**Issue 1
Rate Base for the Test Years**

Ref: Exhibit 2, Tab 1, Schedule 1, Appendix A

Interrogatory # 1

TREE TRIMMING RESPONSIBILITY—(Rule 75-326)

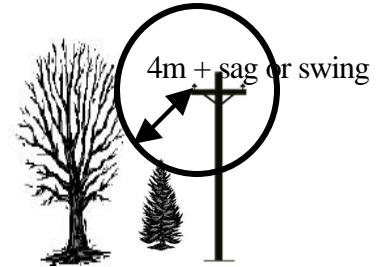
Page 8 refers to the Electrical Safety Code as the source for the company's 9 m right of way width.

Please provide a copy of the code provisions referred to.

The code provisions are as follows: "Rule 75-326 Tree Trimming

- 4m distance plus conductor sag or swing is required from primary lines, including the neutral conductor, to woody growth, or,
- Trimming by the owner to the requirements of the supply authority rule or by-law, or,
- ESA will also accept a statement from the supply authority or distributor confirming they have a program to trim trees on customer owned primary lines to their standard
